**Re: EB-2020-0040 – Niagara Peninsula Inc. (NPEI) 2021 Rates Cost of Service
Interrogatories of the Vulnerable Energy Consumers Coalition (VECC)**

REQUESTOR NAME **VECC**
TO: **EB-2020-0040 – Niagara Peninsula Inc. (NPEI)**
DATE: **October 28, 2020**
CASE NO: **EB-2020-0040**
APPLICATION NAME **2021 Cost of Service Rates**

Reference: Exhibit 2, Table 5-28, pages 242, DSP 401-

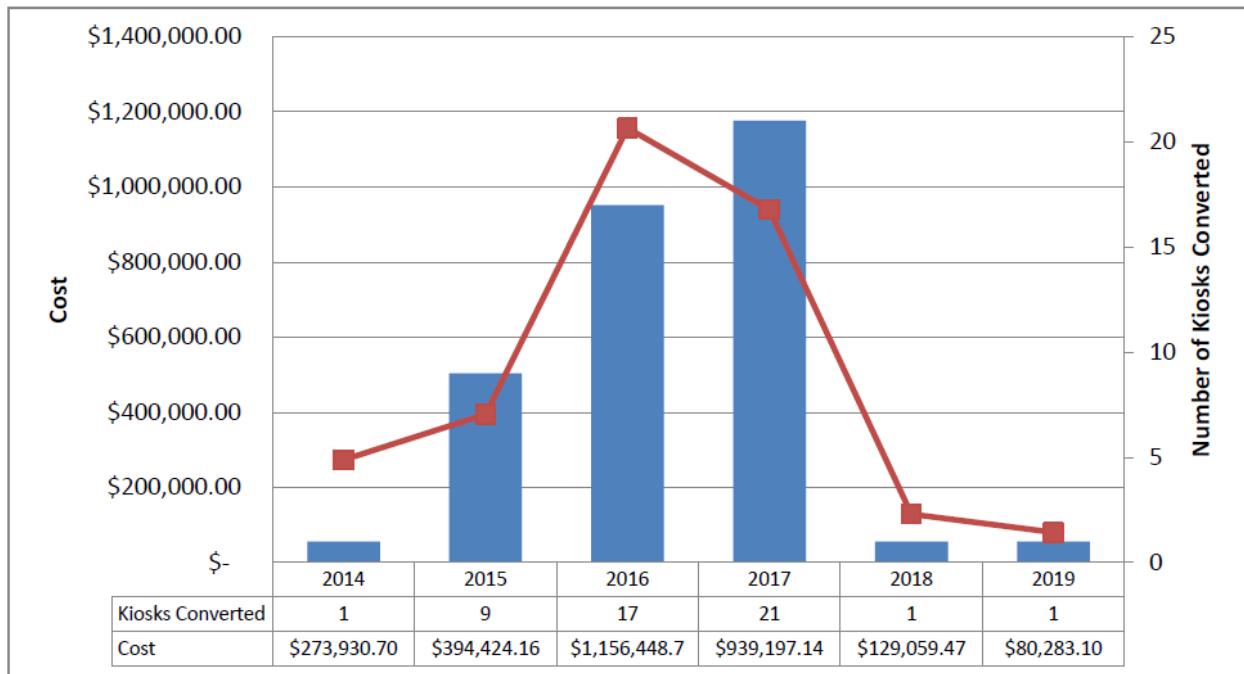
- a) Table 5-28 shows that pole top transformers are subject to visual inspection. If that is correct then how were the polemount transformer replacement (410k in 2021) candidates chosen?
- b) Please show the number of polemount transformers replaced under the pole mount transformer project (i.e. that are not as part of other system renewal programs in each year 2015 through 2025 forecast).
- c) 2025 Please recast the table above to show the expected condition of polemount transformers at the completion of the program.

Reference: Exhibit 2, page 30

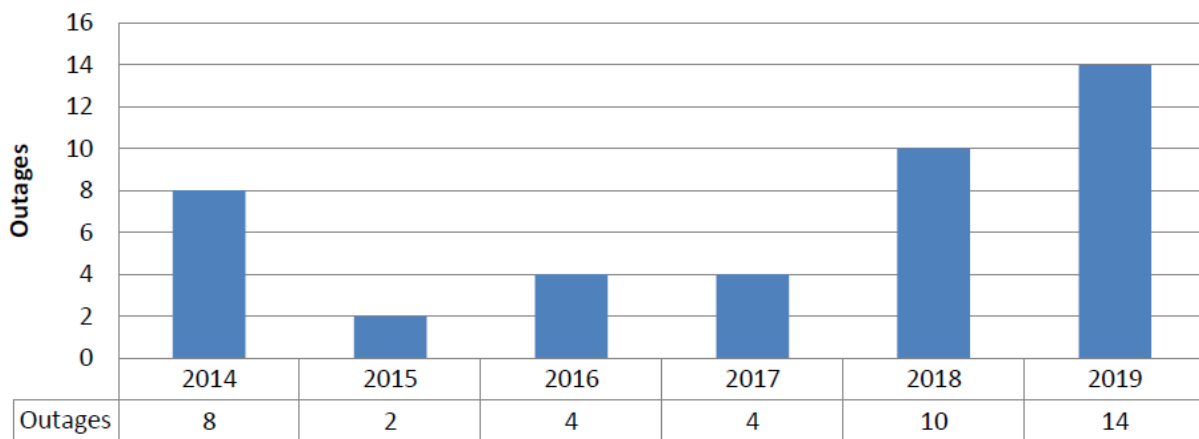
- a) Please provide a table, similar to Table 2.1.1.10 showing building addition capital costs in each of the years 2015 through 2020.

Reference: Exhibit 2, page 109

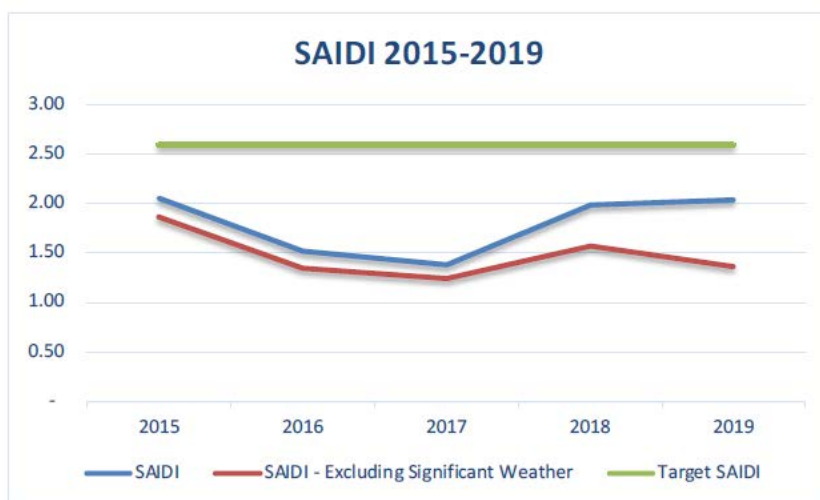
- a) Why does NPEI target SAIDI at a significantly higher level than actually occurred during the 2015-19 period?
- b) What incentives are associated with the SAIDI and SAIFI targets established by NPEI?

Figure 7 Change in Health Index Distribution

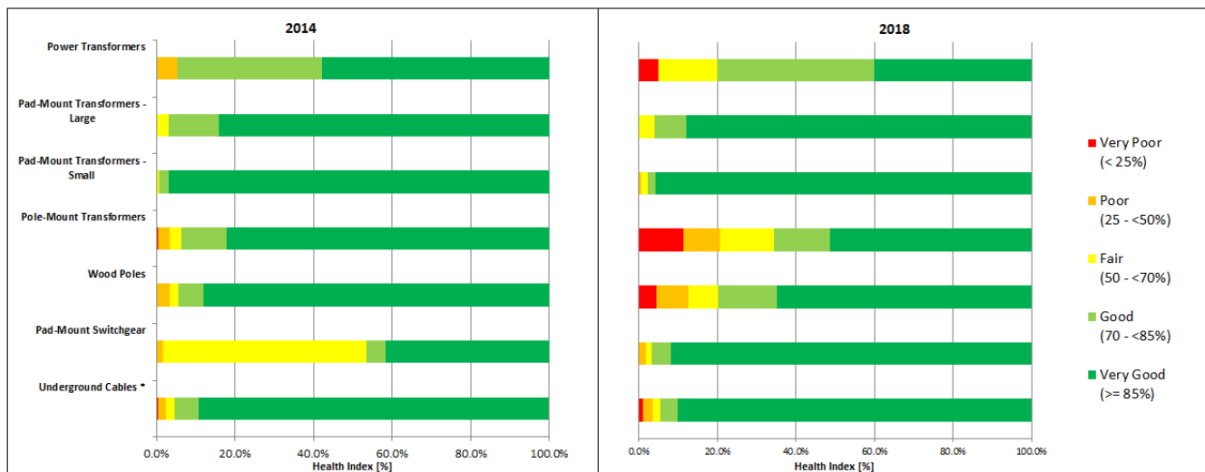
- a) The above chart shows significant changes in the health index for a number of assets most notably, Power and Pole mount transformers and wood poles. Please discuss to what extent the new assessment is the result of (a) changes in assessment methodology or (b) new or better data, and as opposed to showing actual asset degradation over the prior 4- or 5-year period.
